**Economic and Social Council**Distr.: General
18 March 2021

Economic Commission for Europe**Inland Transport Committee****World Forum for Harmonization of Vehicle Regulations****Working Party on Pollution and Energy****Eighty-third session**

Light vehicles: UN Regulations Nos. 68 (Measurement of the maximum speed, including electric vehicles), 83 (Emissions of M₁ and N₁ vehicles), 101 (CO₂ emissions/fuel consumption) 103 (Replacement pollution control devices) and 154 (Worldwide harmonized Light vehicles Test Procedures (WLTP))**Proposal for a new supplement to the 05, 06 and 07 series of amendments to UN Regulation No. 83 (Emissions of M₁ and N₁ vehicles)****Submitted by the expert from the International Organization of Motor Vehicle Manufacturers***

Figure 1
Concepts for road load determinations

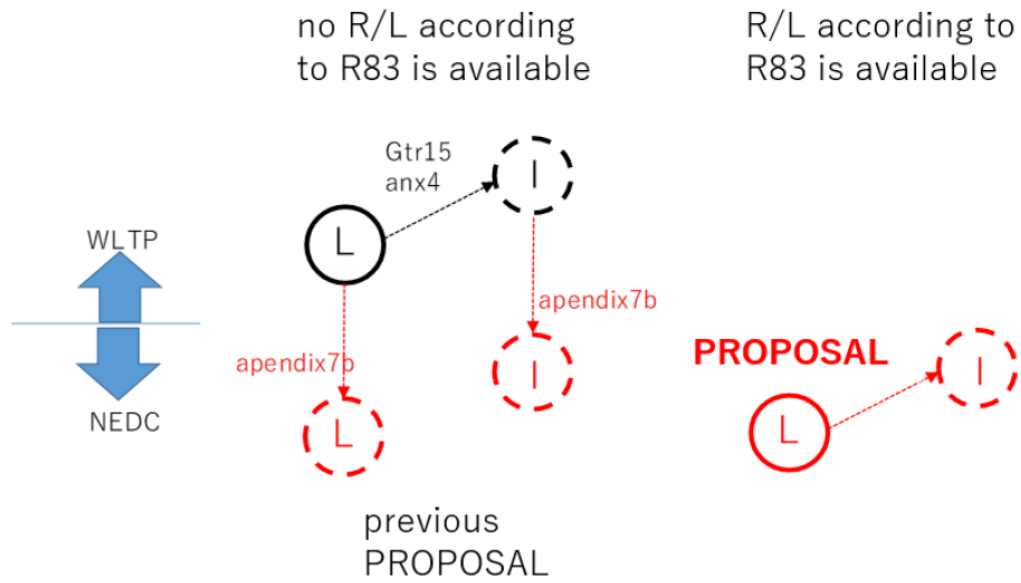
(a) **In the case where the vehicle road load has already been determined according to WLTP procedures as defined in UN GTR No. 15, the methodology, described in Appendix 7b may alternatively be used.**

(b) **In the case where a vehicle road load has already determined according to Appendix 7a to this annex, simulation of the other configurations of the vehicle which have same body shape or same transmission and type approval authority approves the simulation methodology proposed by the manufacture.**

4. During the 80th session of GRPE, the alternative methodology converting WLTP road load to NEDC was adopted. In the case where NEDC road load has been already determined, the conversion from such data to the other version considered to be equivalent.

5. This concept is attached in Figure 1 for information.
